No. 87-4

MCM 420 Exhaust Pipe Repair and Installation

Figure 1. Checking Exhaust Pipe Flange

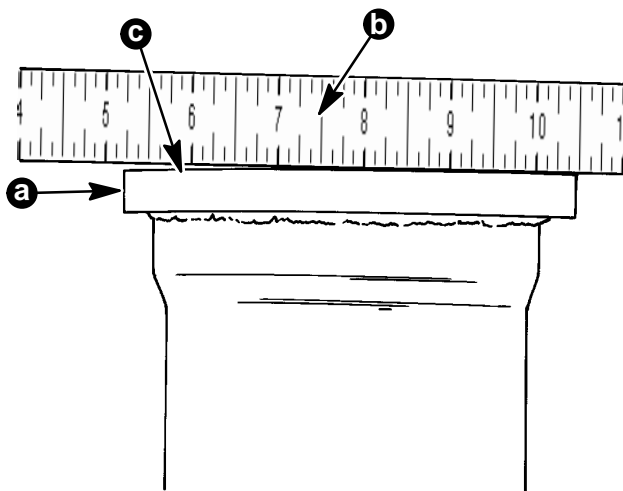
MerCruiser Service has received some reports of water entering the engine on MCM 420 engines. After investigation into the problem it was found that the mounting flanges on the stainless steel exhaust pipes may be warped. If this surface is warped water can leak into the exhaust system from between the exhaust pipe and exhaust elbow. All MCM 420 engines in the following serial number ranges should have the exhaust pipes removed and the mounting flange checked for warpage. (Figure 1)

Engines in these serial number brackets must be checked for warped exhaust pipe flanges.

- a - Flange
- b - Straight Edge
- c - Gasket Surface (Must Be Flat Within .010" (.25mm))

Figure 2. Proper Exhaust Pipe Installation

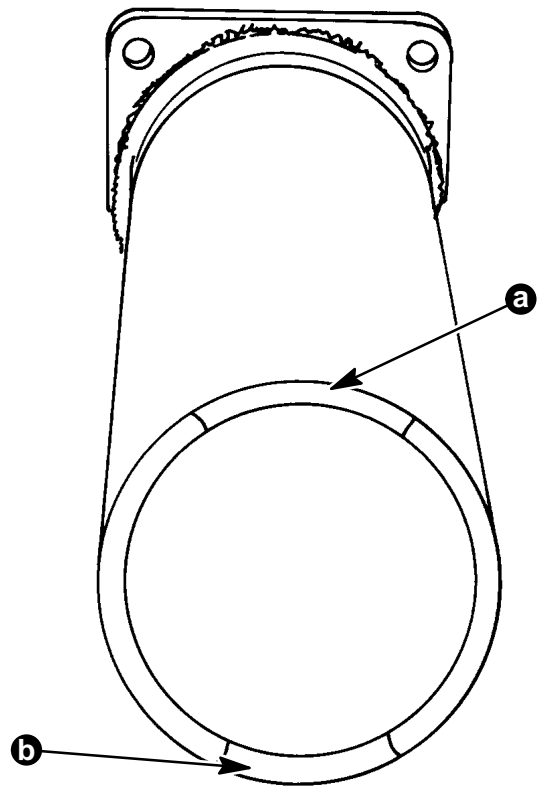
When installing the 420 exhaust pipes it is imperative the pipes be installed properly or exhaust hose burning may be experienced. The exhaust pipe must be installed with a water discharge slot at the 12 o'clock position and a weld at the 6 o'clock position. (Figure 2) Failure to do so may cause hot spots on the upper half of the exhaust hose. Future exhaust pipes will be stamped "top" on the mounting flange for ease of correct installation. After installing the pipes properly if they are not marked "top" place an "X" on the top surface of the exhaust flange.

- a - Water Discharge Slot at 12 O'clock
- b - Weld at 6 O'clock
